**SUBJECT:** NuScale Power, LLC Supplemental Response to NRC Request for Additional Information No. 134 (eRAI No. 8934) on the NuScale Design Certification Application

## **Response to Request for Additional Information Docket No. 52-048**

### **NRC Question No.: 03.07.02-15**

Figure 1-1. RXB Elevation View Showing Gravity Loading (in red).

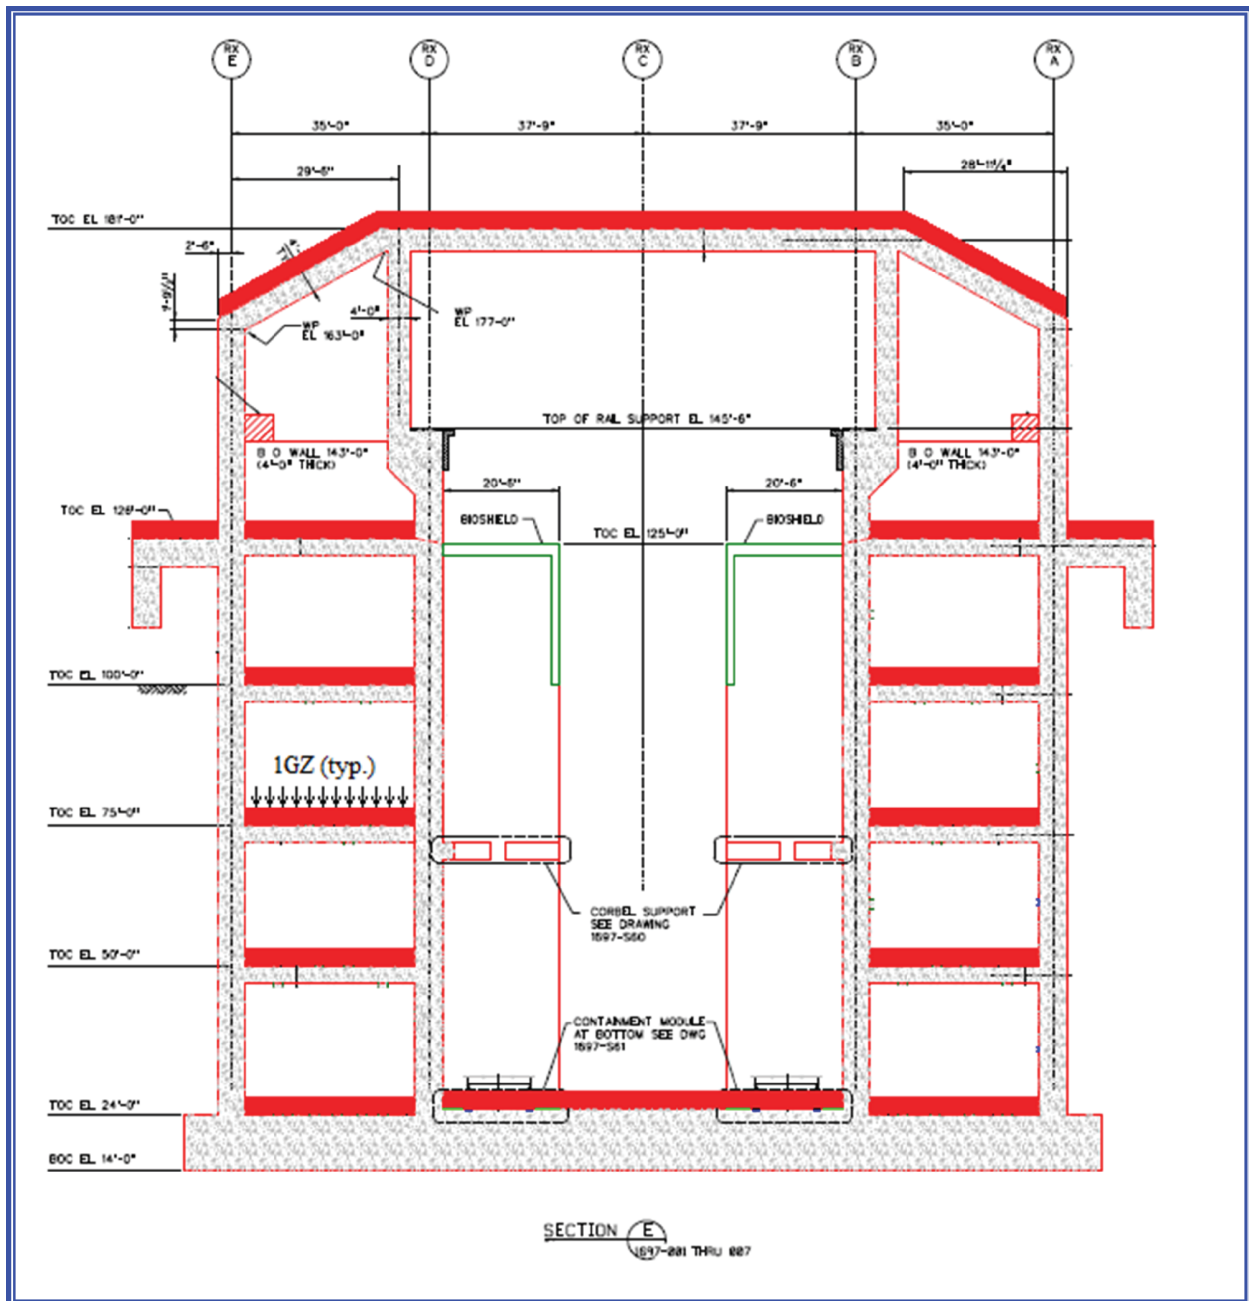
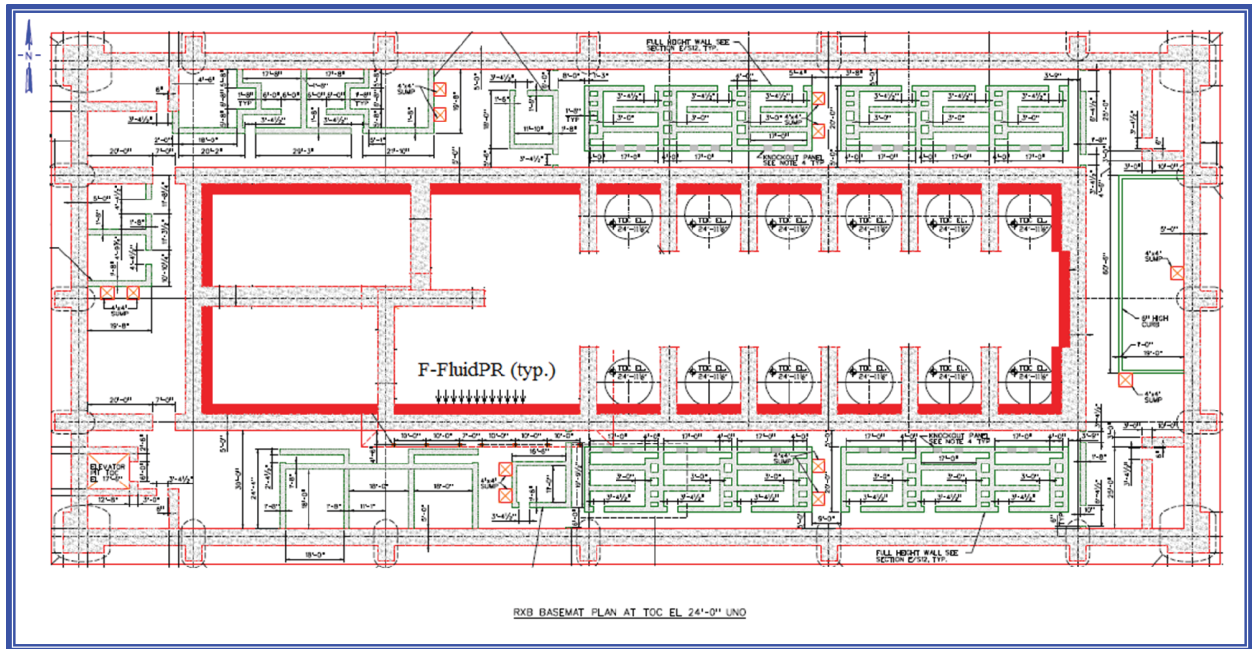
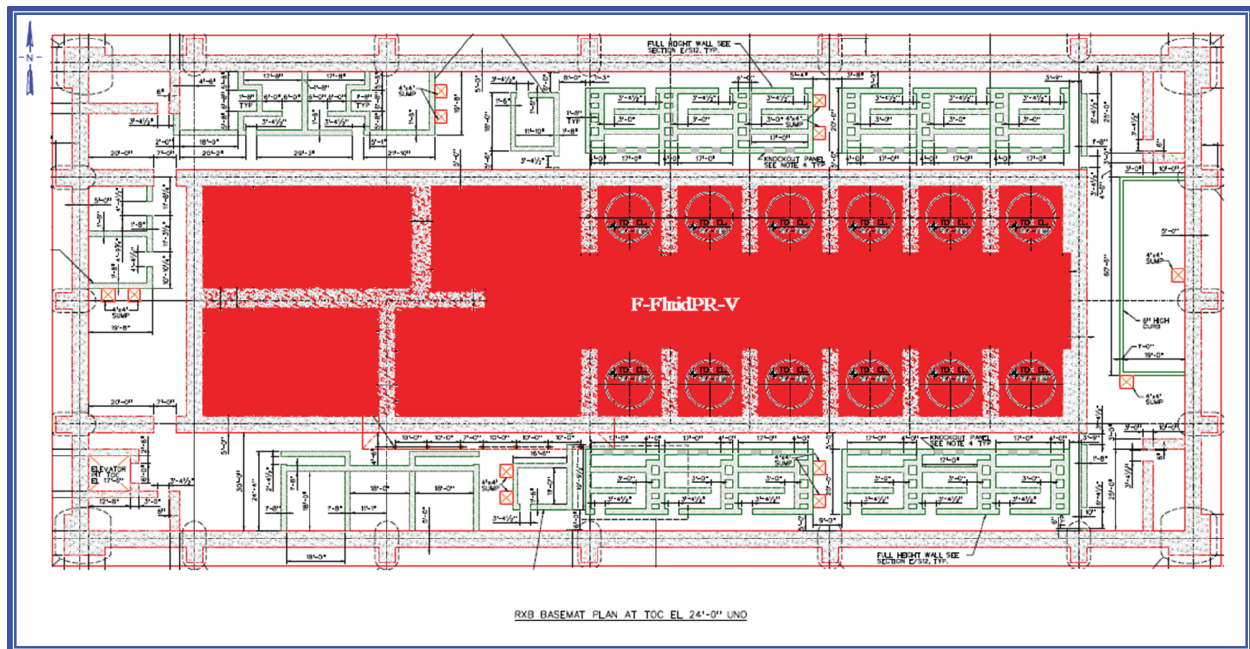
Therefore, the applicant is requested to provide figures or tables that compare pressure profiles on the pool walls and foundation obtained from the actual missing FSI pressure and from amplifying the gravity load by a factor of 1.28. If significant differences are identified in such comparison, the applicant should provide an evaluation demonstrating that the use of a gravity load factor of 1.28 results in an incremental design demand (forces, moments, deformations, etc.) that would have bound the increased demand should the applicant have used the actual pressure profile accounting for the missing FSI effect in SAP2000, for both the RXB pool walls and foundation.

Response: NuScale has performed analyses that confirm that the 1.28 x gravity load bounds a 4.2psi pressure profile and is providing these results as part of this response.

Figure 1-1 shows a cross-sectional elevation view of the RXB and the inertial loading in the vertical direction. Figure 1-2 shows a cross-sectional plan view of the RXB and the fluid pressure loading in the horizontal direction. Figure 1-3 shows a cross-sectional plan view of the RXB and the fluid pressure loading in the vertical direction. Figure 1-4 shows a cross-sectional elevation view of the RXB with the combined soil pressure and fluid pressure for the static portion of ACI Equation 9-6.
